SERVICE BULLETIN

Bulletin No: JC-011-11REV1

Product: G Series ProCat and Predator-Pro models.

Issue: Lower Seat Cushion Tearing

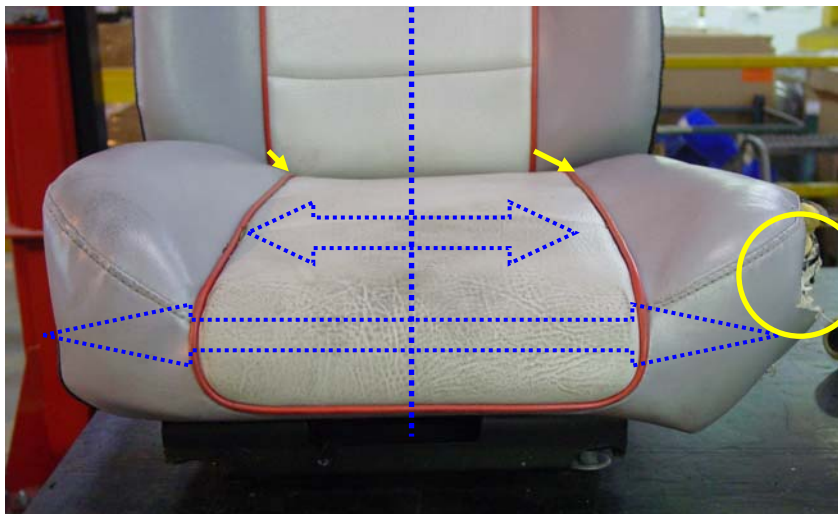
Cause #1: The bolt used in production is too long and can tear the seat.

Revision 1: Cause #2- Lower Seat not manufactured to engineering specifications causing misalignment and seat base shifting that can cause seat tearing. See image below.

Notice that the seat base above is off to one side, the red piping on the lower seat cushion does not line up with the piping on the back cushion and the seat base has torn from rubbing against the control arm.

Action Required Cause #1: Turn the bolts around in the control arms to eliminate seat interference and replace the seat cover if torn.

Action Required Cause #2: If you encounter a misaligned **Cause #2** seat with tearing (like shown above), complete replacement of the seat assembly (#4165316) is required. Please order a replacement through your local distributor.

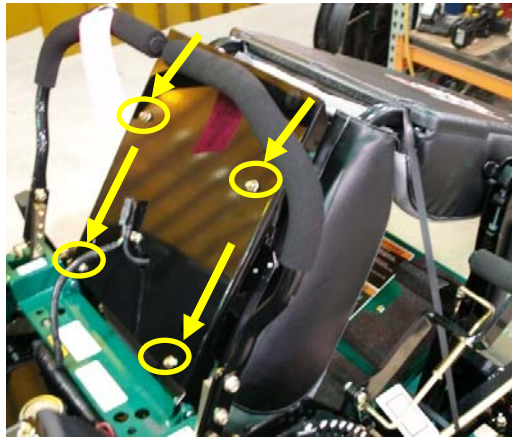
1. Mower Serial Number
2. Photo of the seat from a front view (see page 1)
3. Photo of Seat Serial Tag (as shown below)

Note: The serial plate is located on the bottom of the actual seat, not the seat pan you see when you flip the seat forward. Remove the seat from the seat pan to see the serial tag.
